RFB-2022-19
RENOVATIONS TO: SCHENECTADY COB LOBBY
C2 DESIGN GROUP

ADDENDUM #1

Issued Date: 06/13/2022

1 First Floor Life Safety Plan
SCALE: 1/4" = 1'-0"

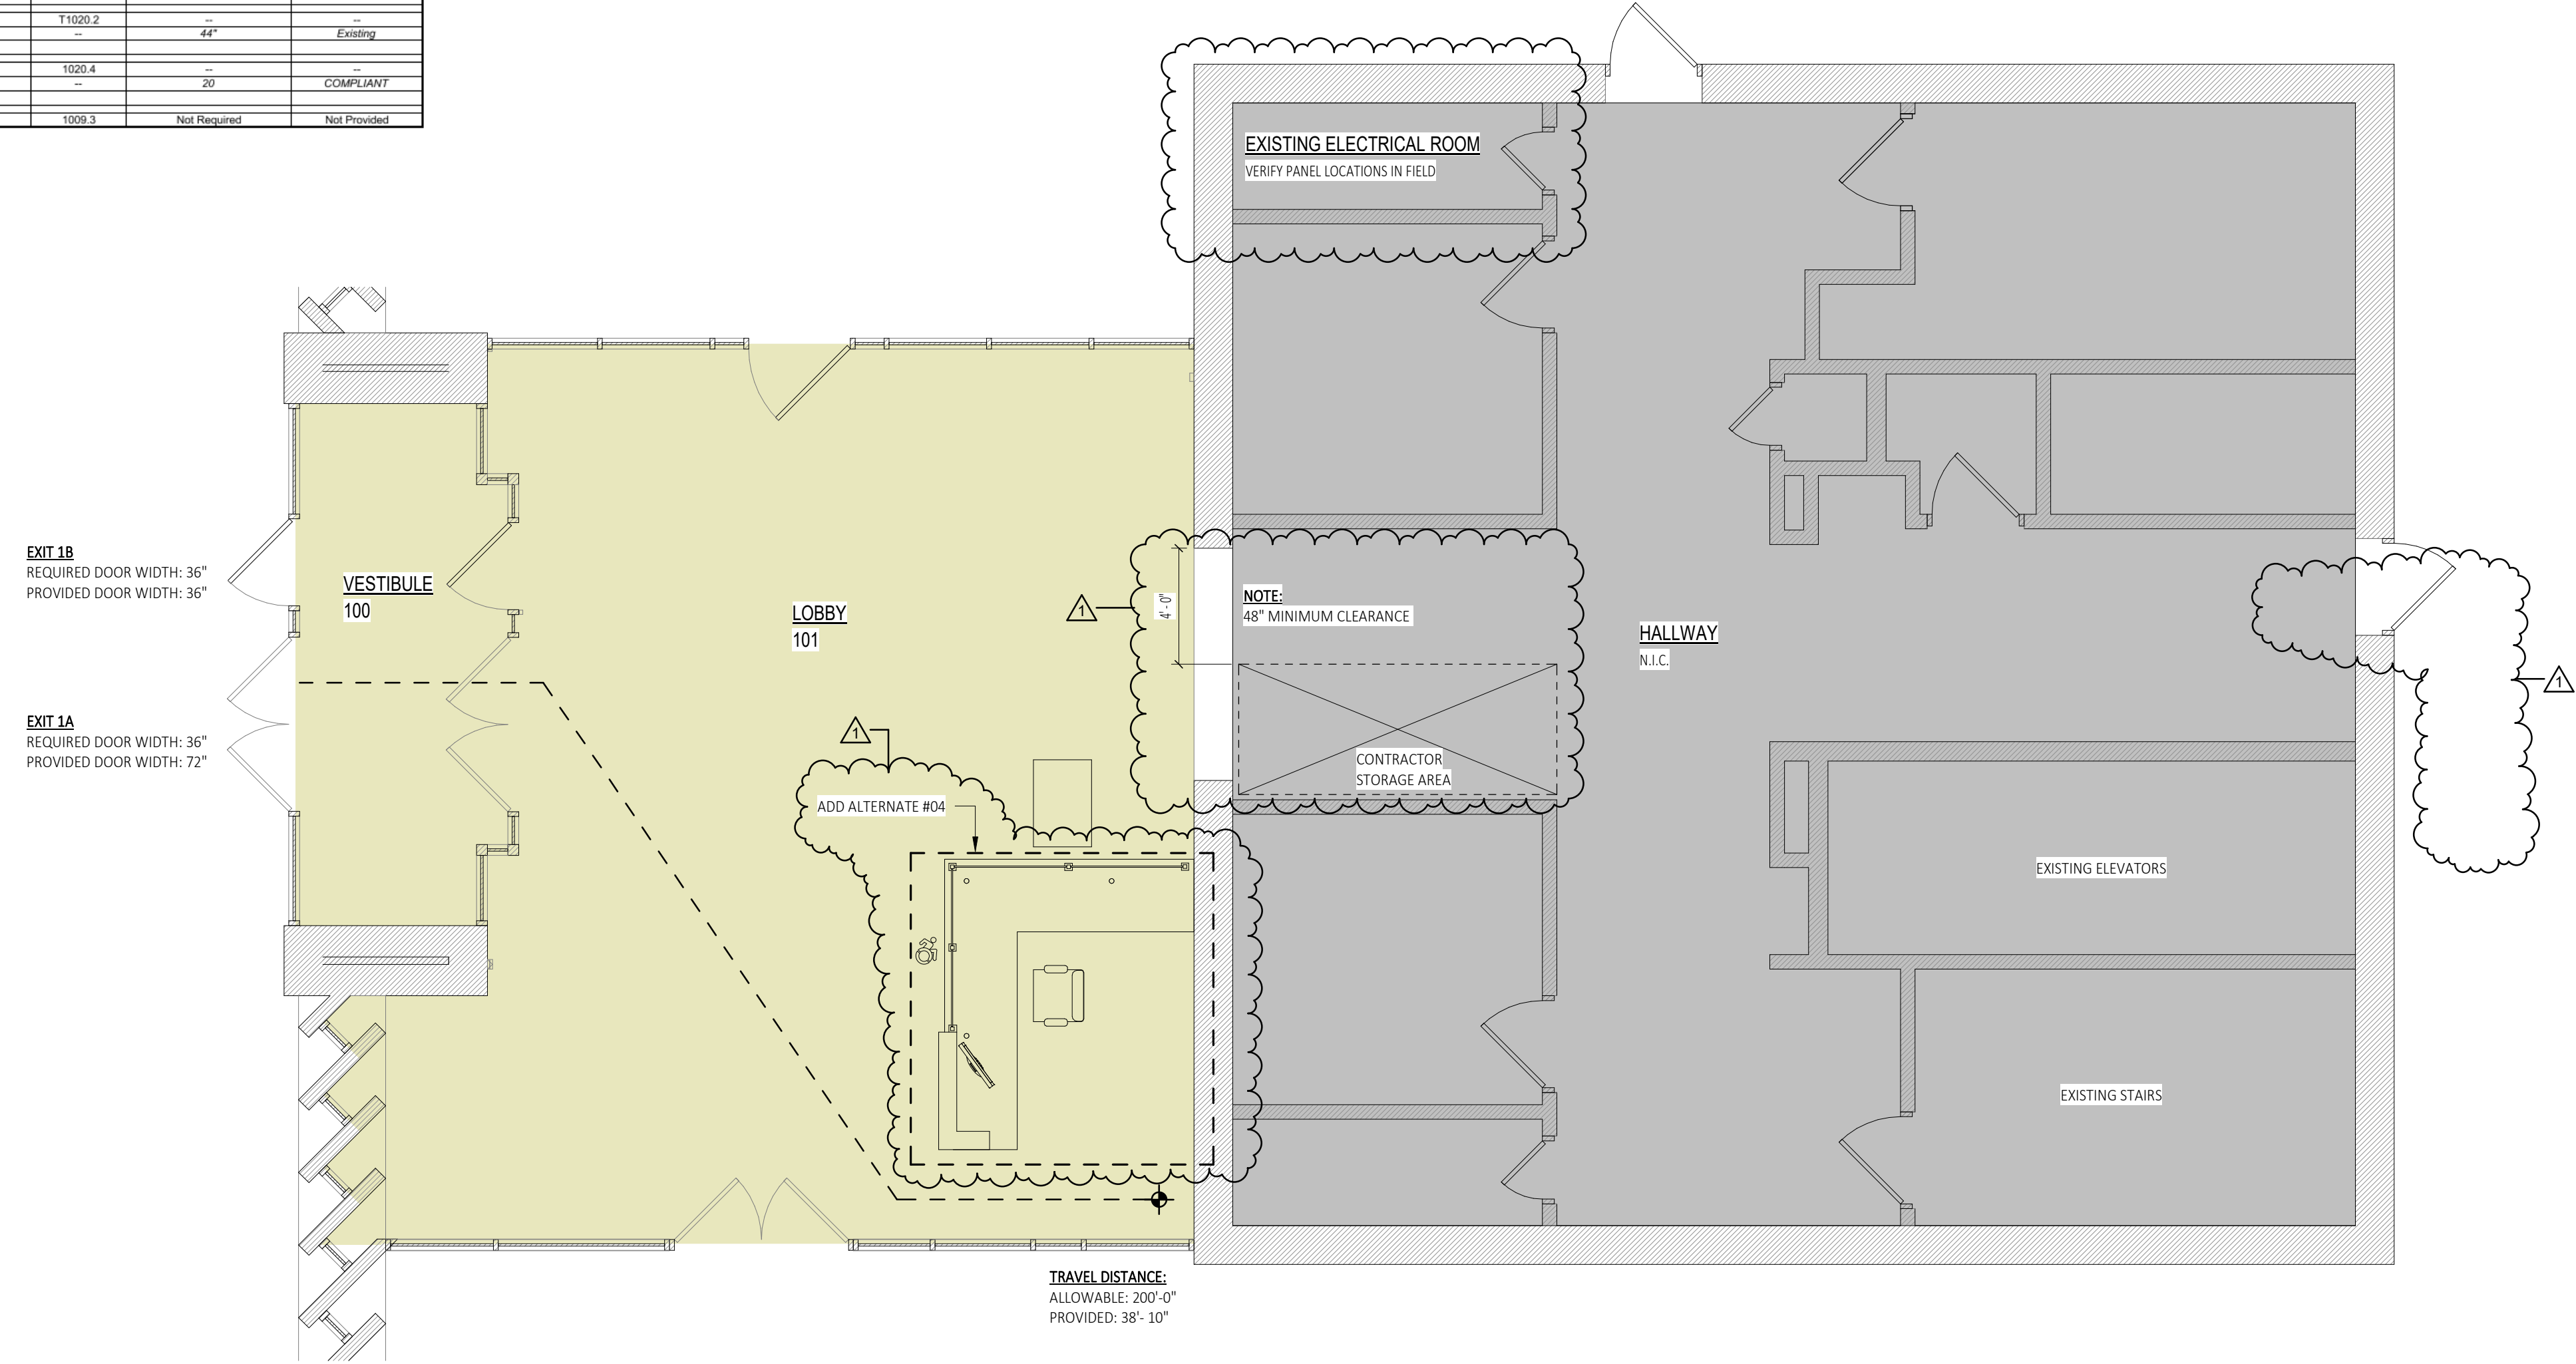
5. Where is the proposed "Site Lay Down Area"?
 - a. Response: See Drawing G200 Addendum #1.
6. Is fencing required?
 - a. Response: Temporary (mobile) fencing required at public entrance and daily working areas.

GENERAL CONSTRUCTION
GROUND FLOOR PLAN
RYDER & LINK, ARCHITECTS
122 JAY ST., SCHENECTADY, N.Y.

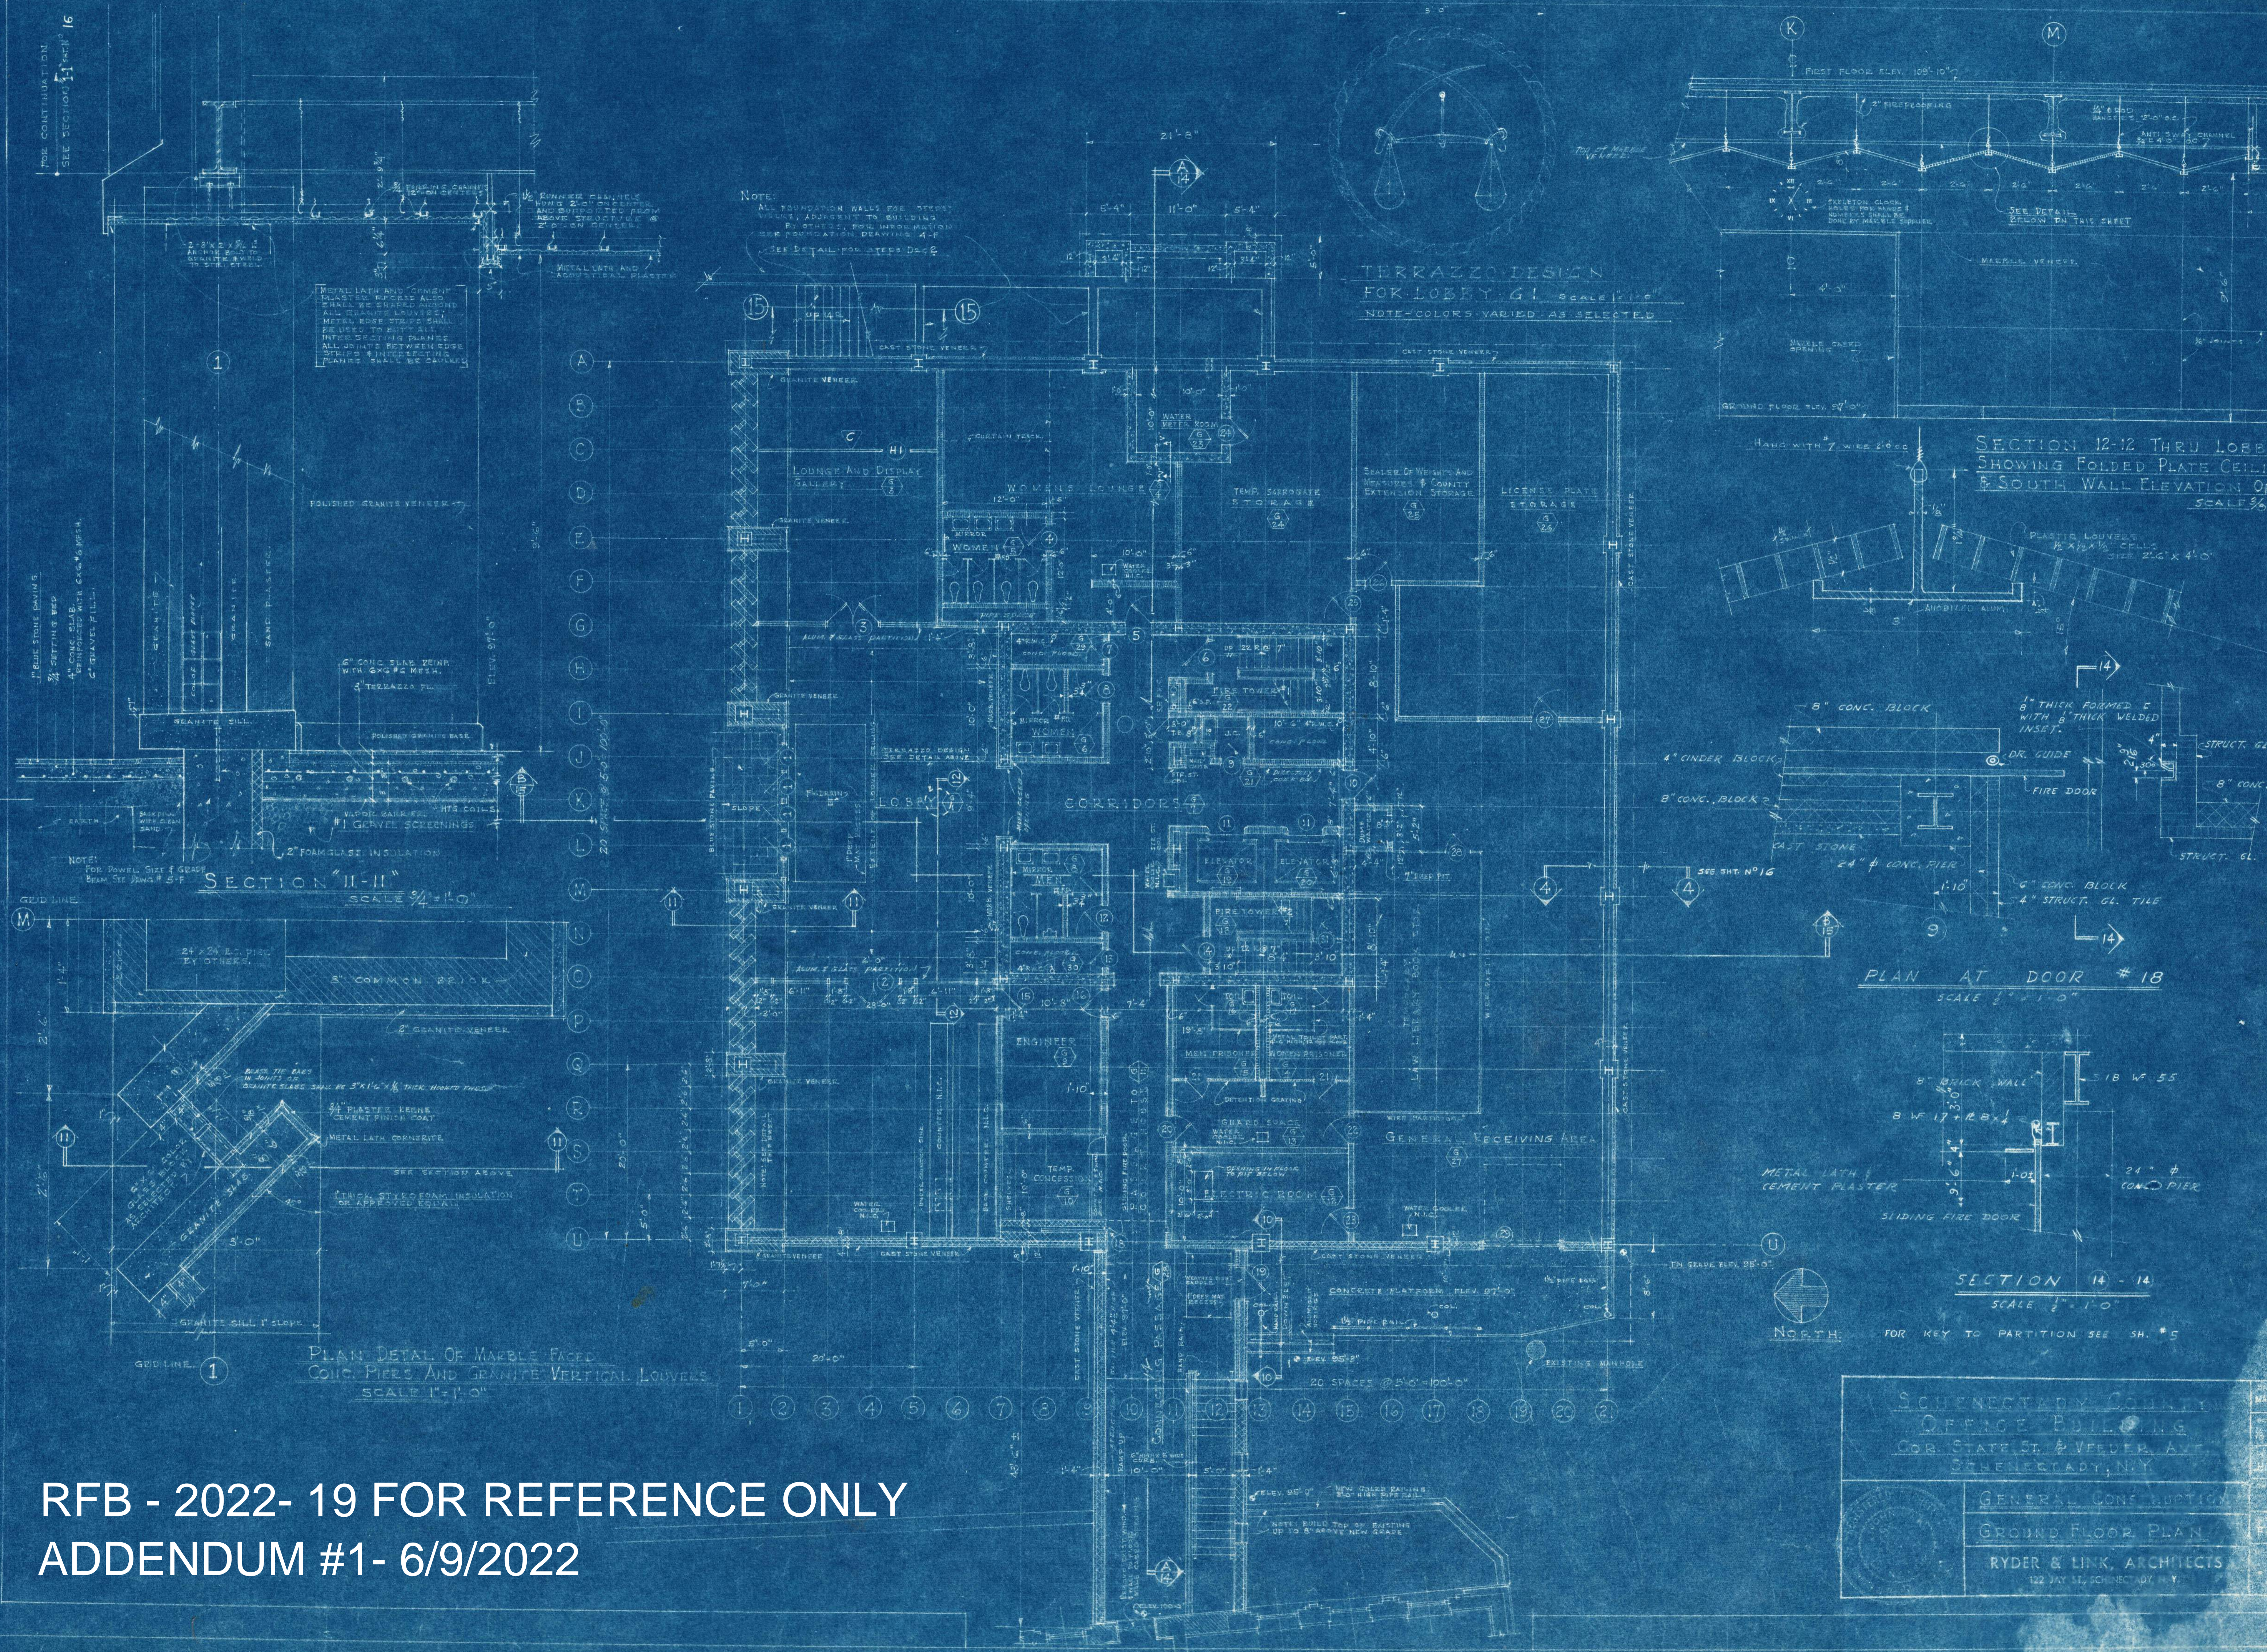
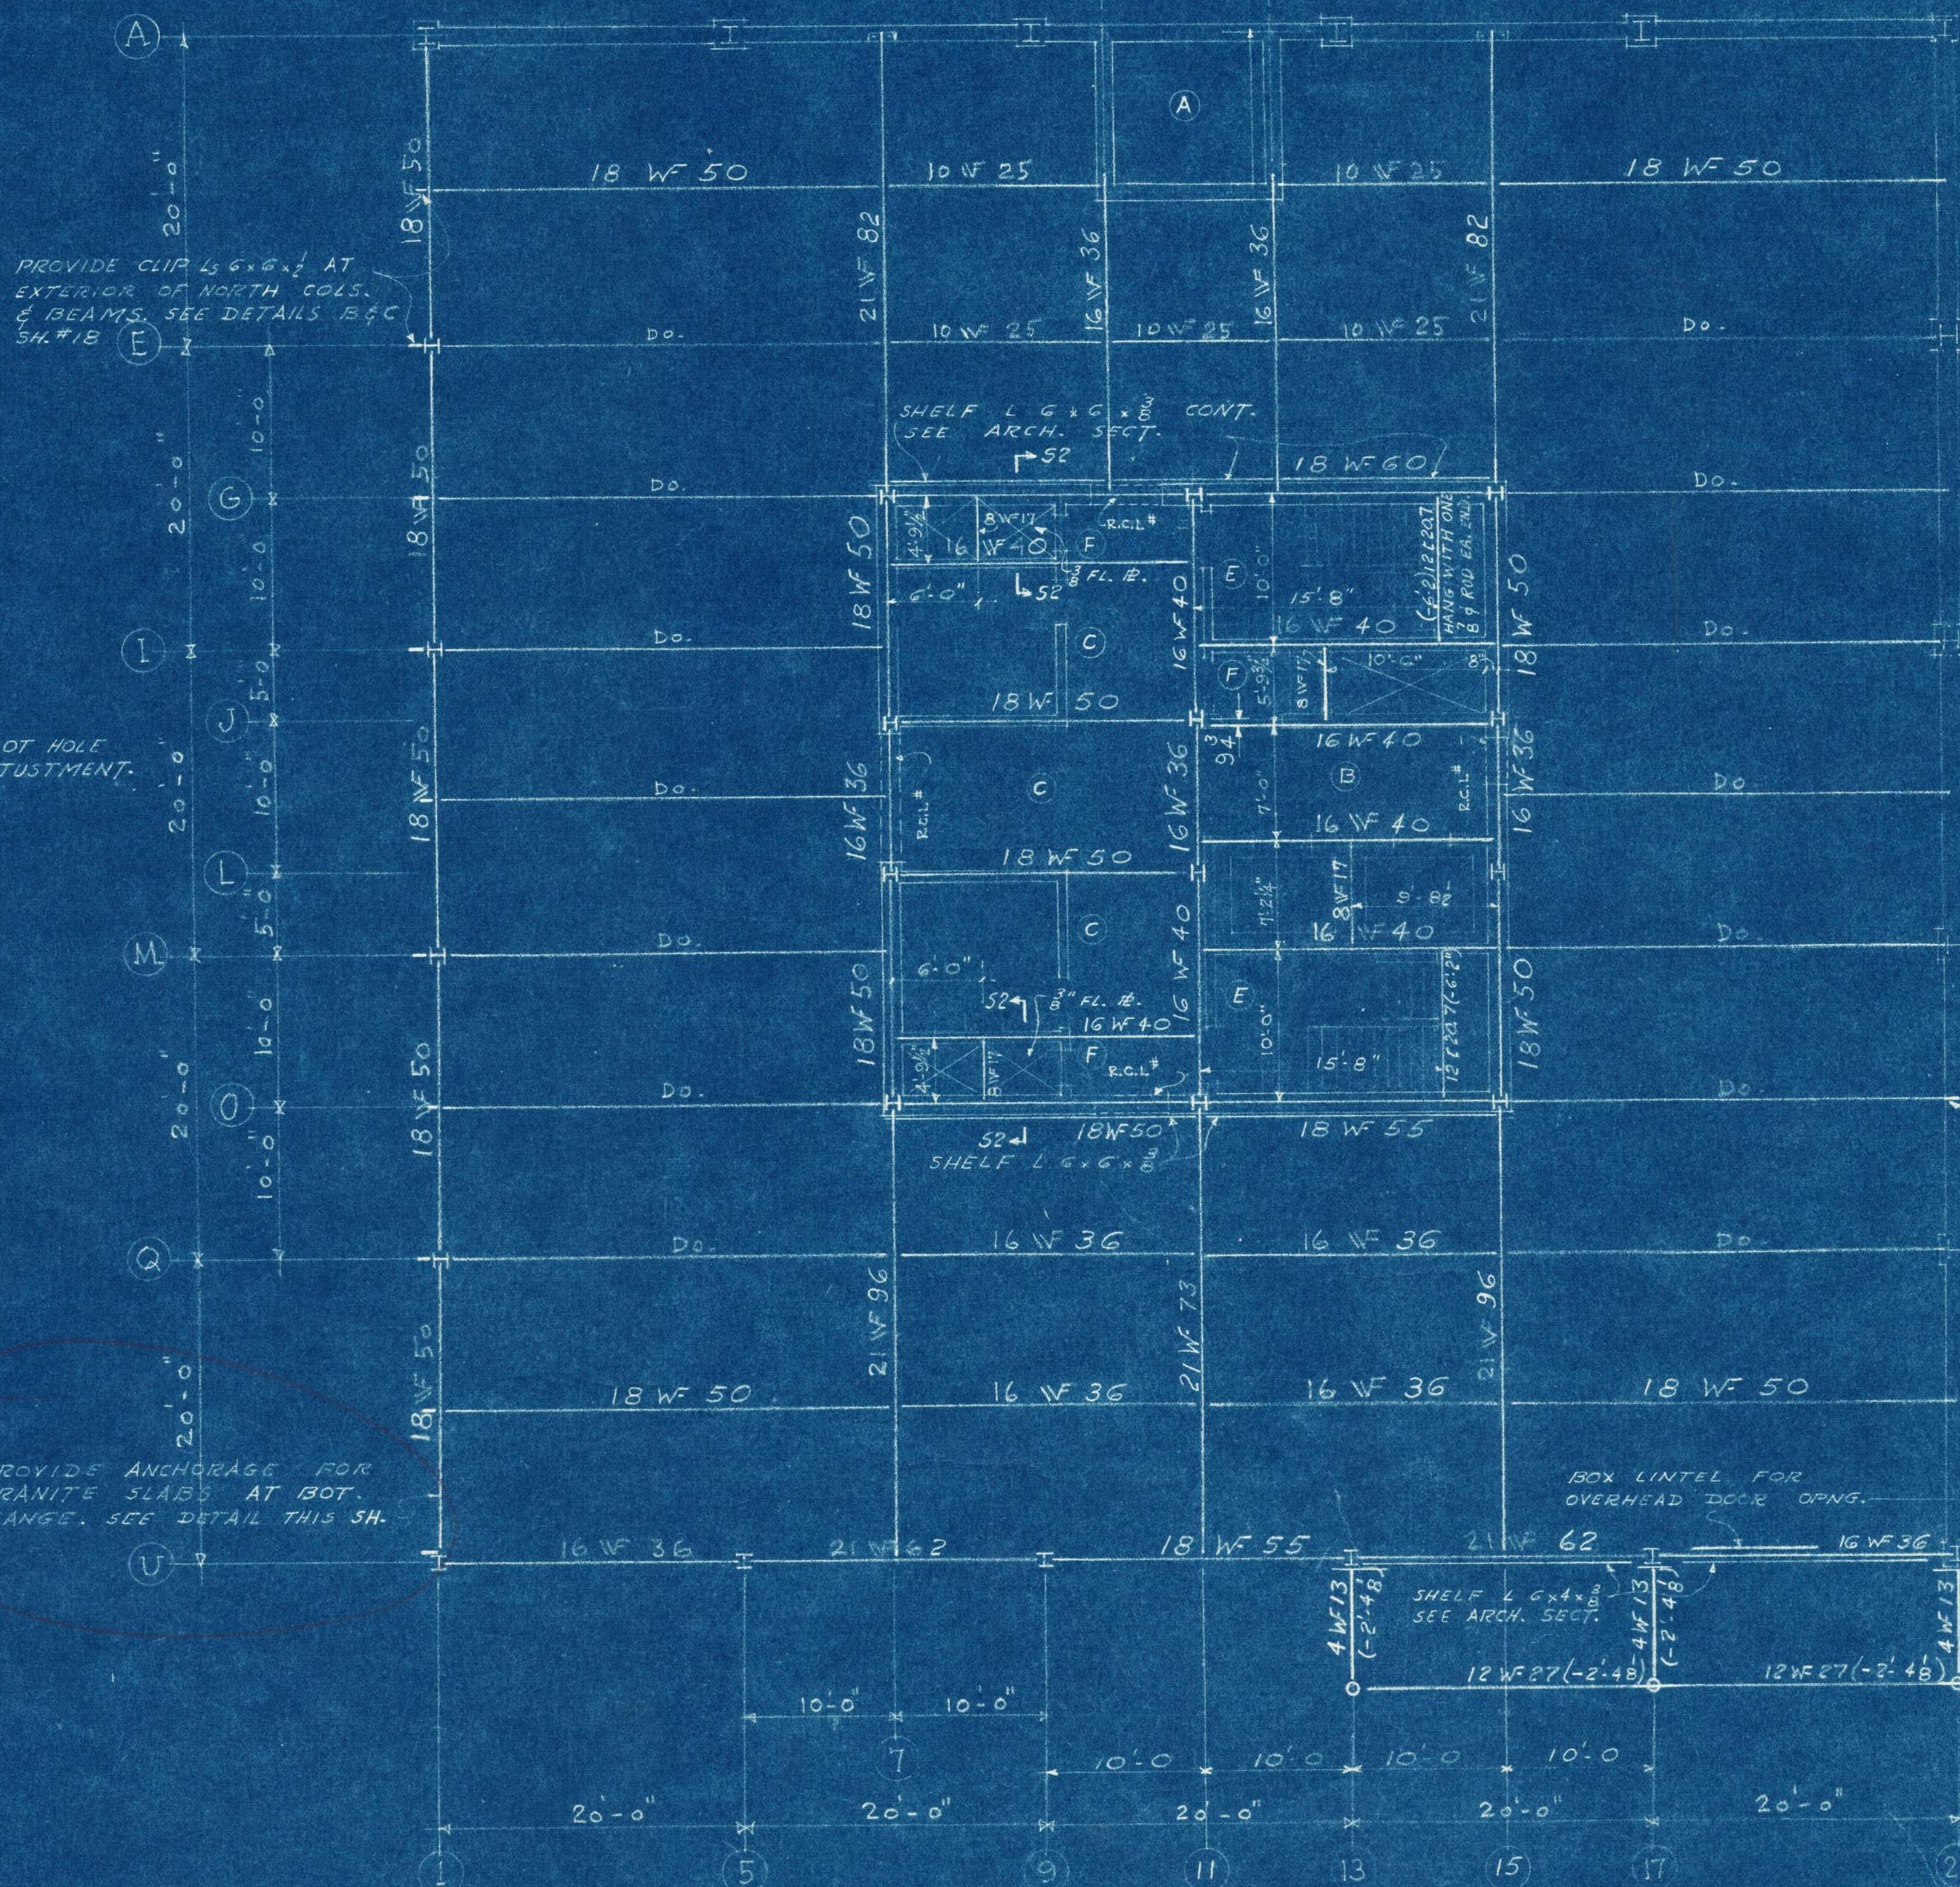
1. What is the height above the drop ceiling to the deck?
 - a. Response: Heights of existing conditions must be verified in field. See attached existing building reference drawings for additional information. (Note: Reference drawing may not document all current conditions.)

2. Is the deck concrete or steel? If steel, is it corrugated or flat? What are the existing steel sizes?
 - a. Response: Existing conditions must be verified in field. See attached existing building reference drawings for additional information. (Note: Reference drawing may not document all current conditions.)
